TB10055

<b>Topic:</b>		<b>TB No.:</b> 10055	<b>Date:</b> 14/01/2021
<b>Affected Machines:</b>	Ecoboiler PB5/PB10	<b>Priority:</b> Low	<b>Created By:</b> Eddie Purtil
<b>From Serial No.:</b>	All	<b>Created For:</b> Technicians	
<b>From Date:</b>		<b>Pages:</b> <u>2</u>

### ***Solenoid 1502148 stem resize.***

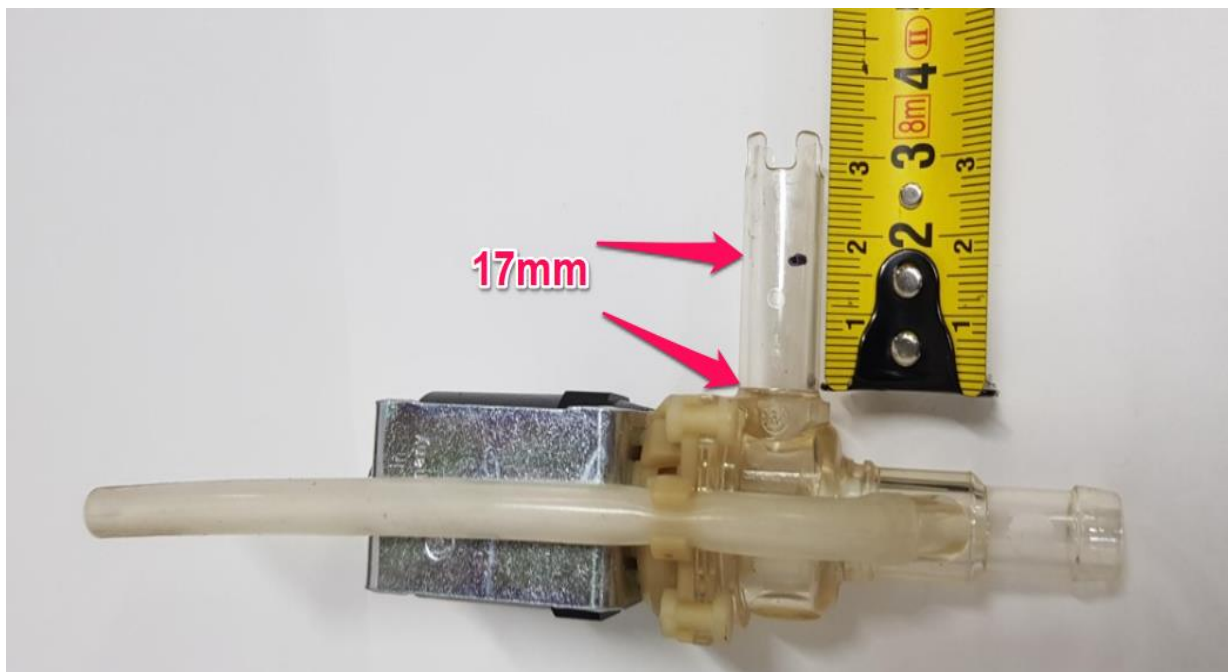
*In order to reduce parts Marco adopted one valve for both Ecoboiler and Ecosmart(LED screen) push button models.*

The dispense valve p/n 1502148 inlet stem must be cut to fit the **Ecoboiler Push Button range**. Please see below image.

**Ecosmart PB does not need to be cut.**

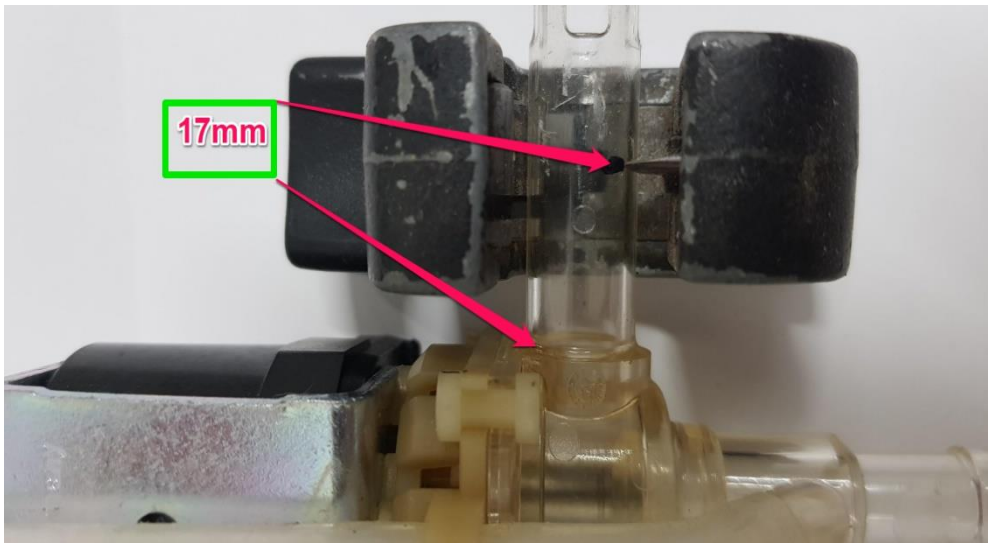
Measure 17mm as below

Cut the valve stem using a pipe cutter as shown. Please note a hacksaw shouldn't be used as swarf could get into the valve and cause it to jam open.

*If you do not have a pipe cutter, and you must use a hacksaw, place a tissue into the valve to prevent any plastic swarf from entering the valve and wash out after cutting!*
